**Washington Office Virtual AOP Design
Assistance Team**

Assessment of a Simplified Design Method for Aquatic Organism Passage on the Tongass National Forest

Final Report

Prepared for the Tongass National Forest
and Region 10.

Figure 11. Stream has primary flow in flood channel after large storm at 20rd-102.907mp. The crossing has very poor stream to structure geometry.

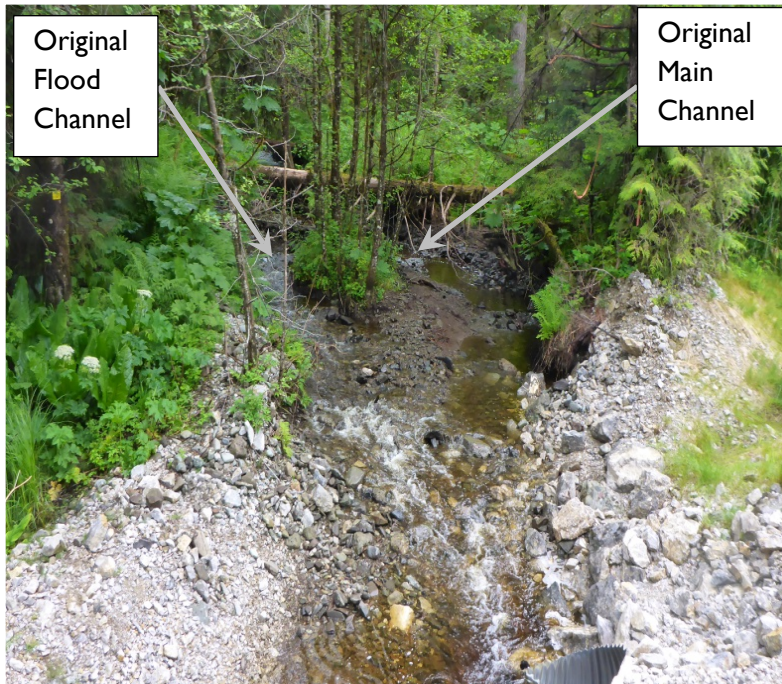
An example of lateral adjustment is at 20rd-102.907mp which has room for lateral movement in its floodplain (see Figure 11). A vegetated island upstream, likely the aggraded sediment wedge from the previous undersized structure, has allowed the channel to switch flow paths after recent high flows. Now the main channel follows the original flood swale on river right. This site has poor hydraulic alignment (approach angle between the stream and the structure) no matter which flow path the stream occupies. Poor hydraulic alignment inevitably results in higher potential for debris and sediment accumulation, loss of hydraulic capacity, and increased likelihood of road-fill scour at the pipe inlet
